FIELD SERVICE BULLETIN

FSB Number: LVCCFSB2004-120
Author: Tony Bryan
Date: July 16, 2004
Total No. of Pages: 4
Subject: **GSM Triplets - Flip Detect Switch**
Model Affected: GSM V300, V303, V400, V500, V525, V600
Level of Repair: 2

Diagram 1.0 - Contamination from Side-Key Flex

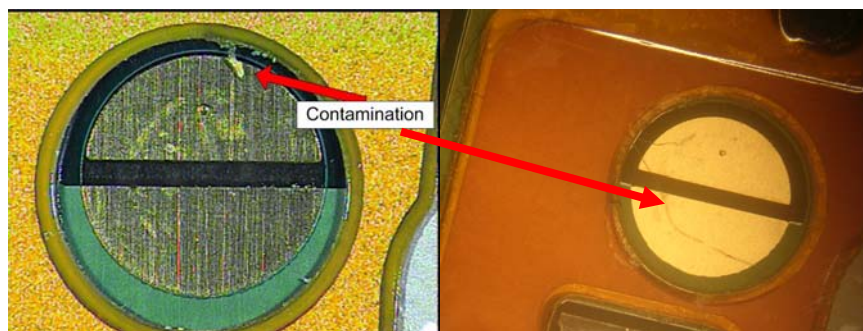
Foreign Material: The main source of the foreign material was the side-key flex, where some excess material would extend over the cutout for the flip switch contacts (S550). See diagram 1 below.

Foreign Material: Supplier Process Improvements including the use of side-key flex with a non-fiber based peelable paper. Factory Process Improvements including increased inspection under magnification for foreign material.

Diagram 2.0 - Corrosion caused by environments (3888844N01 Sinco Keypad)

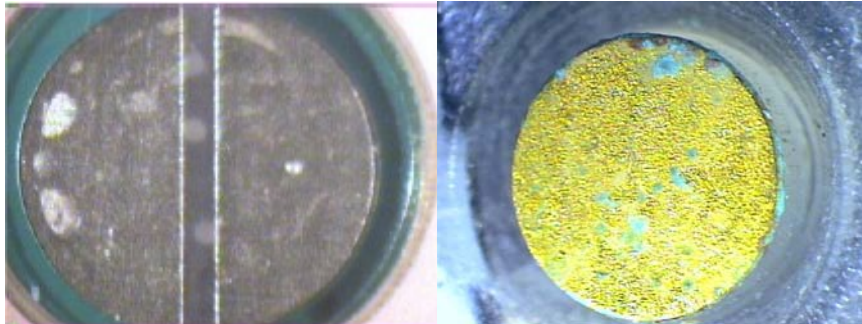
Corrosion: The main source of the corrosion was isolated to the 3888844N01 keypad supplied by Sinco. The gold pucks sourced by Sinco were sub-standard in quality and had a high susceptibility to corrosion when exposed to environmental conditions in the field. See diagram 2 below. In addition, the Sinco keypads had an additional air port which directed air inward towards the contact increasing the opportunity for field failure. The 3888844N01 keypad is used on V303, V400, V500 and V525.

Corrosion: The 3888844N01 Sinco keypad was redesigned to remove the extra air vent, which was leading to a higher susceptibility to foreign material, completed 12/31/2003. Sinco began sourcing higher quality gold pucks from Shin-Etsu on February 22, 2004. Sinco obtained and crossed over to new supplier, with improved quality, for the gold pucks as of March 31, 2004. Motorola changed the specification for the keypad where an aggressive salt spray requirement was added.

V500 Keypad from SINCO

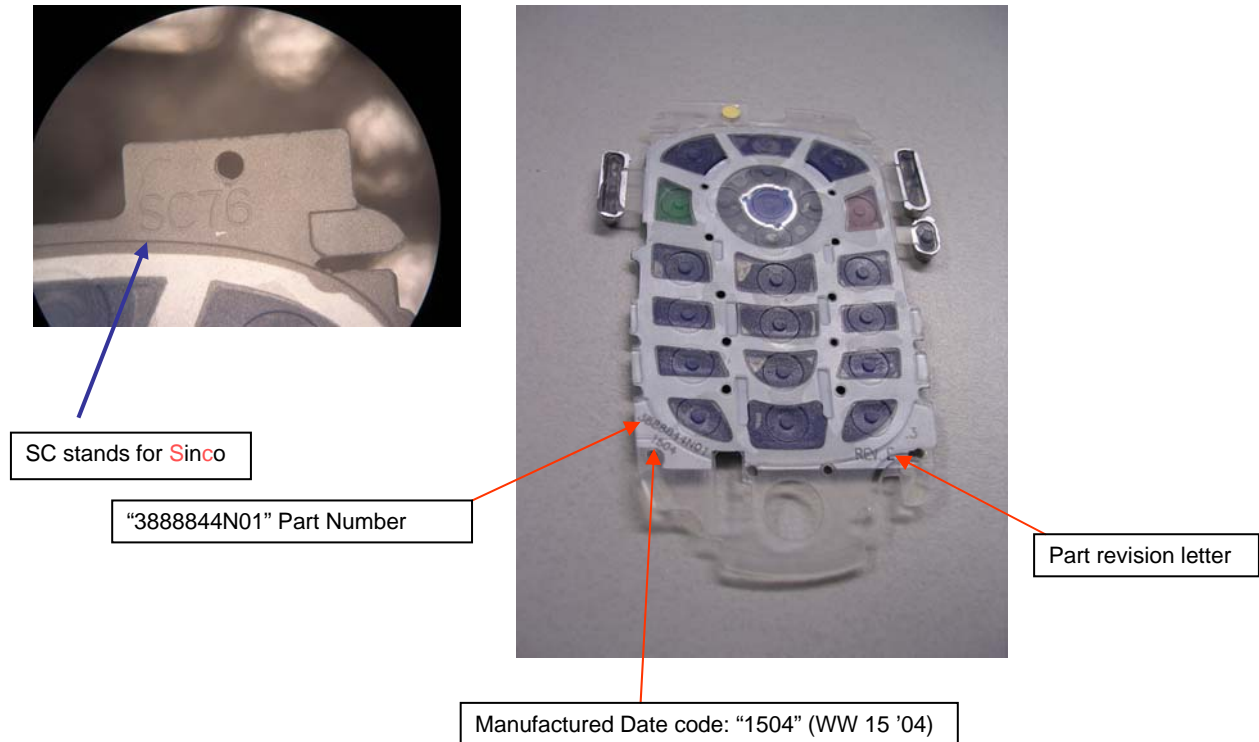
Note: When servicing any GSM Triplet customer return, Service should inspect and replace **all** 3888844N01 Sinco keypads, built prior to WW12 2004, to prevent future reliability issues due to corrosion.

1. Test and evaluate the unit for proper performance of the Flip Switch
 - a. If Flip Switch operates normally, then follow normal troubleshooting procedures to determine the fault per the customer complaint.
2. Dis-Assemble the unit and inspect the PCB contact and Keypad gold puck for foreign material or corrosion, which may be interfering with the gold puck of the keypad making a good electrical connection with the flip switch contacts (S550) on the PCB.
3. Remove any foreign material found from PCB or keypad. IPA (Isopropyl Alcohol) can be used to clean any remaining adhesive residue on the gold contacts.
4. Replace keypad or side-key flex if necessary to repair unit.
